## V2500-A1/A5 NACELLE SERVICE BULLETIN

This document transmits Revision 4 to Service Bulletin NV2500-71-0285 and Revision 4 to the Supplement

# V2500-NAC-71-0285

NACELLE – RIGHT HAND FAN COWL DOOR – HOLD OPEN ROD – RE-ORIENTATION OF THE HOLD OPEN  
ROD AND INSTALLATION OF A NEW ROD STOWAGE BRACKET

Removal of the old Stowage Bracket  
Figure 1

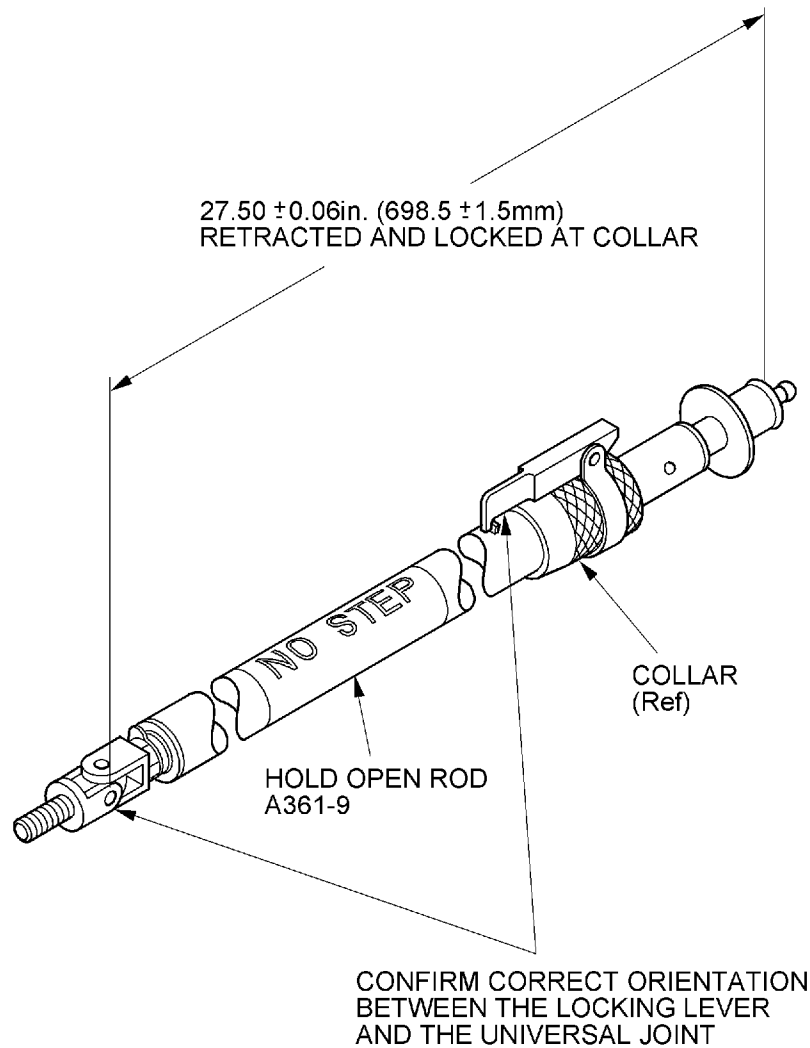
- (1) Remove the three MS20500-1032 Nuts, the three AN960C10L Washers and the three NAS8703U17 Bolts to release the RI361-4A Stowage Bracket from the Fan Cowl Door. Remove the Bracket. Refer to Figure 1.

Dimension check of the Hold Open Rod  
Figure 2

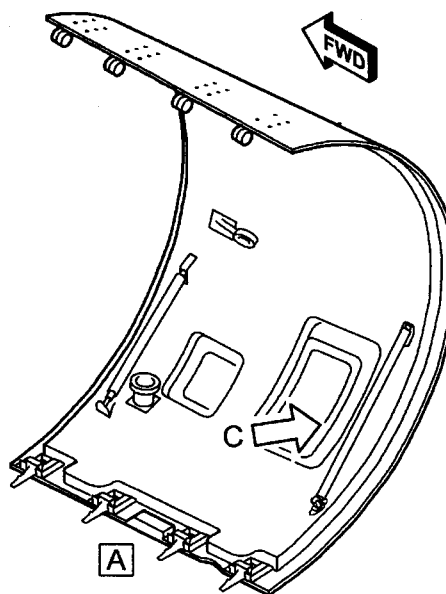
WHEN YOU MODIFY THE HOLD OPEN ROD MAKE SURE THAT THE RE-ASSEMBLED ROD WHEN FULLY RETRACTED AND LOCKED IS TO THE DIMENSION SHOWN IN FIGURE 2. IF YOU DO NOT OBEY THIS INSTRUCTION INCORRECT INSTALLATION OF THE STOWAGE BRACKET CAN OCCUR.

- (a) Do a dimension check on the A361-9 Hold Open Rod when fully retracted and locked and confirm correct orientation Refer to Figure 2.

Figure 3. sheet 1

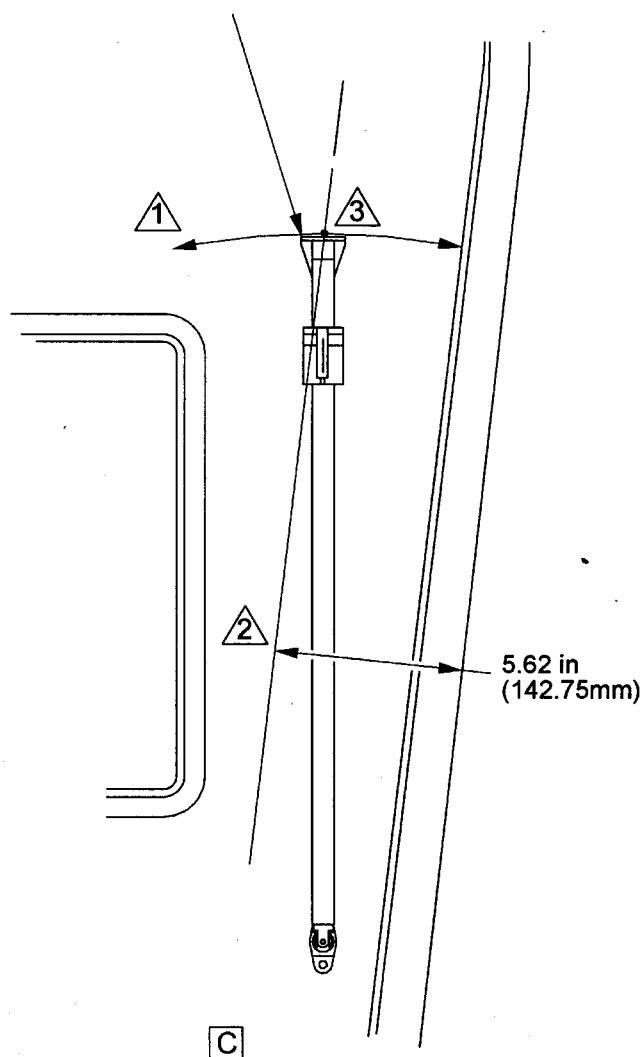
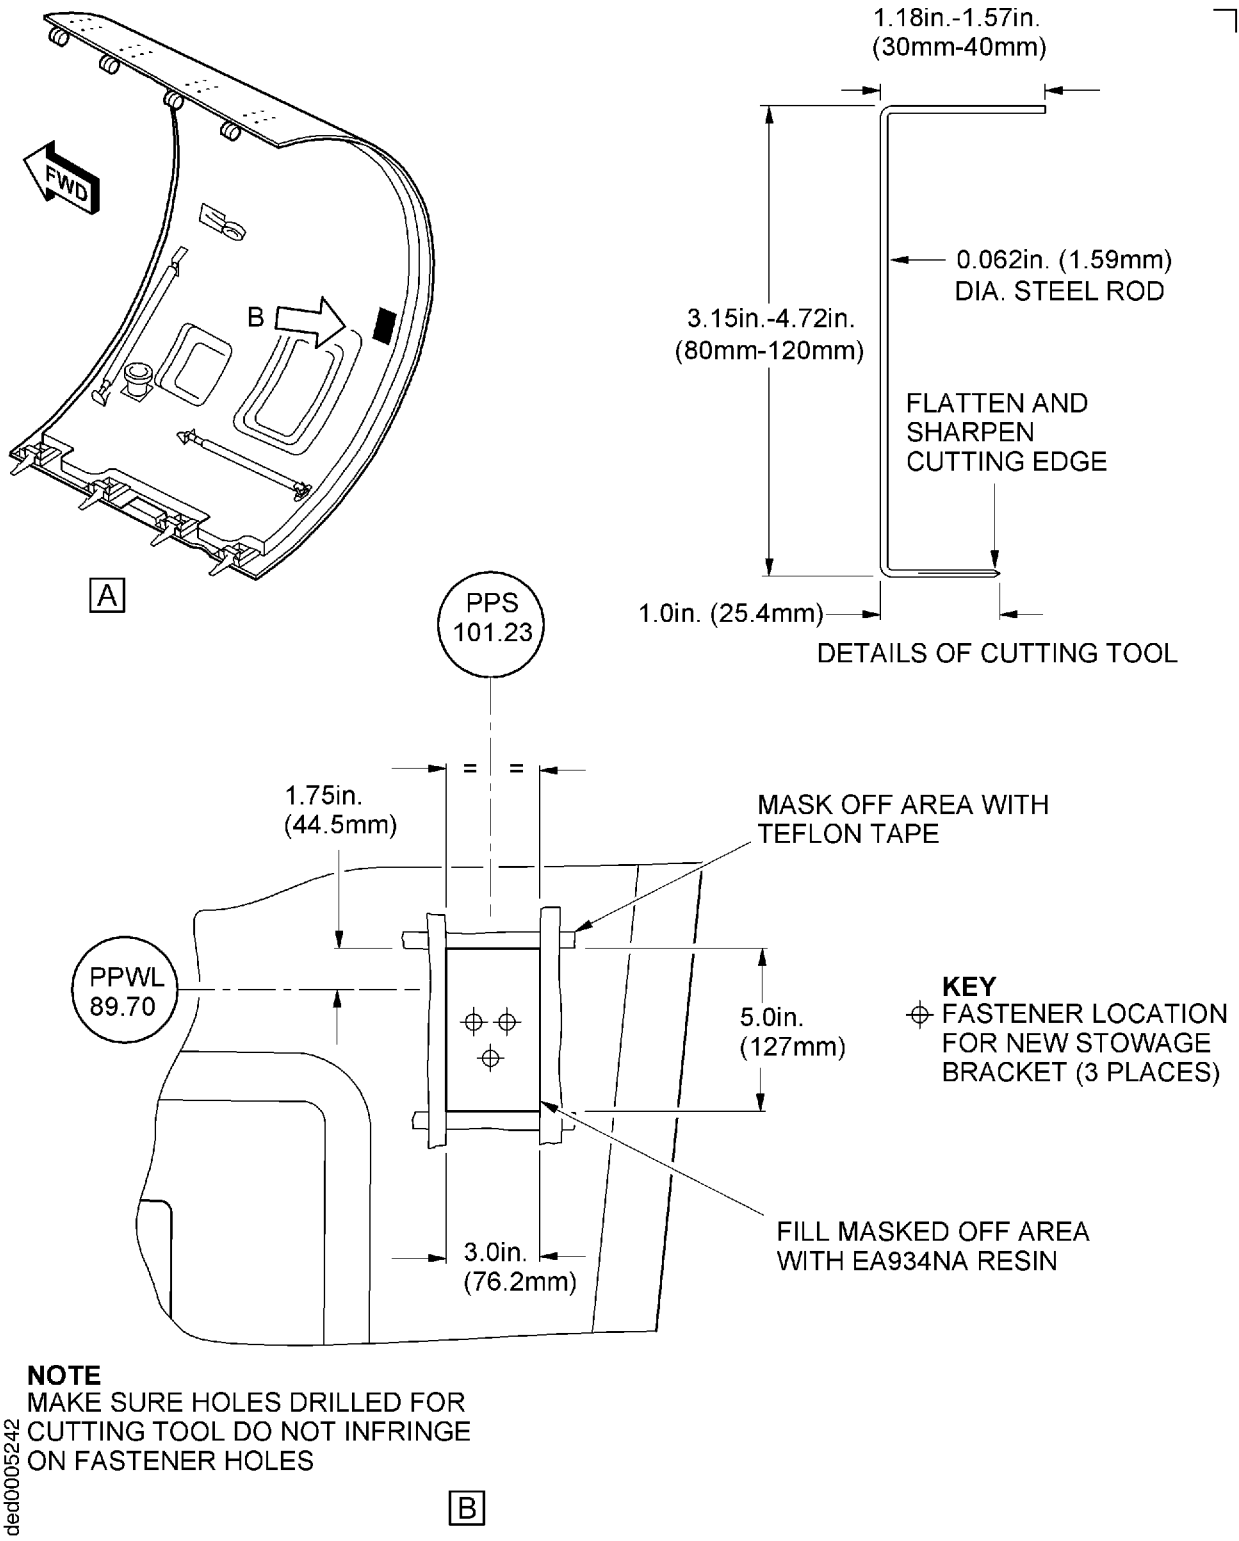
| (c) Locate the R1361-4B Stowage Bracket on the A361-9 Hold Open Rod                                    | Obey the above caution. Refer to Figure 3 sheet 1. Confirm correct engagement with the Hold Open Rod.  |

LOCATE THE R1361-4B STOWAGE BRACKET AS SHOWN AND CONFIRM STOWING OF HOLD OPEN ROD

Mark an arc from the centre of stowage bracket

Mark a parallel line from the edge of the door

Locate the centre of the bracket where the arc and parallel line intersect

Re-location of the Hold Open Rod and Installation of the new Stowage Bracket  
Figure 3 Sheet 2

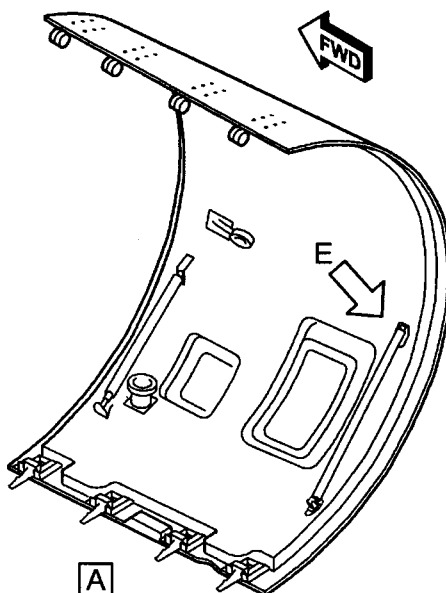
| (a) Make a cutting tool  | Refer to Figure 3 sheet 2.          |

Re-location of the Hold Open Rod and Installation of the new Stowage Bracket  
Figure 3 Sheet 3

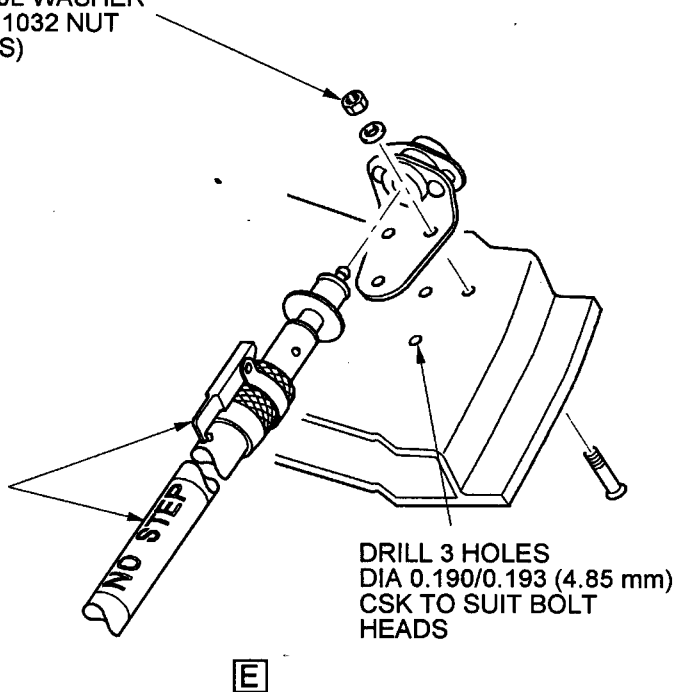
CONFIRM THAT THE HOLD OPEN ROD IS CORRECTLY ORIENTATED AS SHOWN IN FIGURE 3 SHEET 3. IF YOU DO NOT OBEY THIS INSTRUCTION DAMAGE TO THE ROD OR ADJACENT HARDWARE CAN OCCUR DURING THE FAN COWL DOOR CLOSING PROCEDURE.

Refer to Figure 3 sheet 3.

INSTALL  
NAS8703U17 BOLT  
R1261-4B STOWAGE BRACKET  
AN960C10L WASHER  
MS20500 1032 NUT  
(3 PLACES)

CONFIRM  
RELEASE LEVER AND  
DECAL ARE ORIENTATED  
AS SHOWN

FIGURE 1

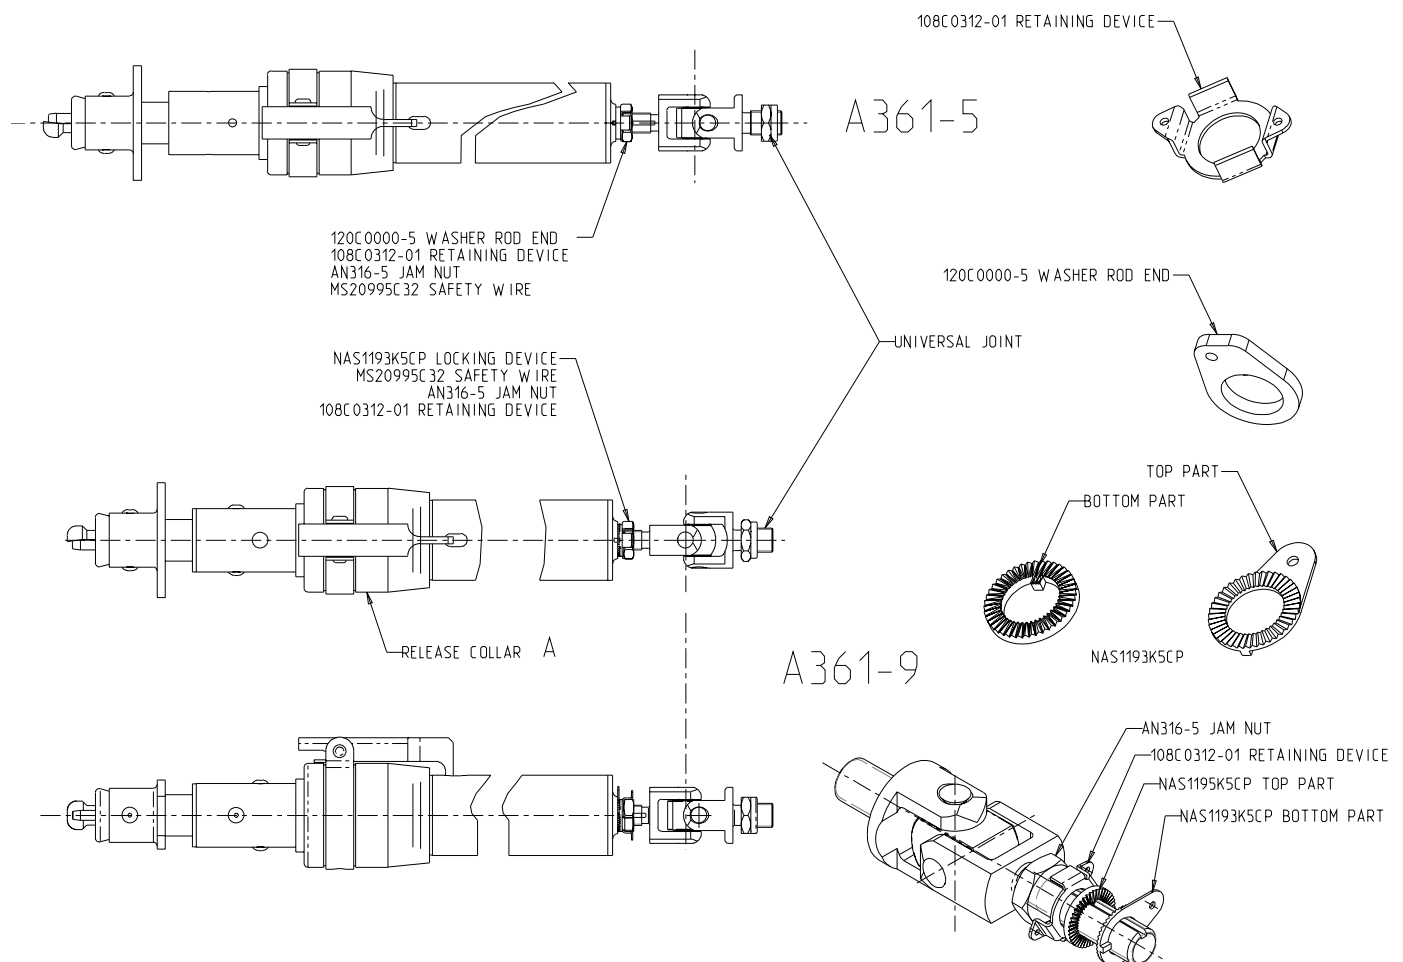
#### A. Disassembly (See Figure 1)

#### B. Assembly (See Figure 1)

- (6) Thread universal into strut end fitting by rotating clockwise.
- (7) Continue rotating until extended and locked length of  $43.00 \pm .06$  is obtained.
- (8) Adjust position of universal joint as shown on figure 1.
- (9) Engage key on top part of NAS1193K5CP with slot in strut end fitting
- (10) Engage serrations of bottom part with top part.
- (11) Rotate jam nut AN316-5 and retaining device 108C0312-01 together clockwise until contact with NAS1193K5CP is made.
- (12) Torque jam nut AN316C5 to 30/50 lb.-in.
- (13) Install new safety wire MS20995C32 in accordance with MS33540.
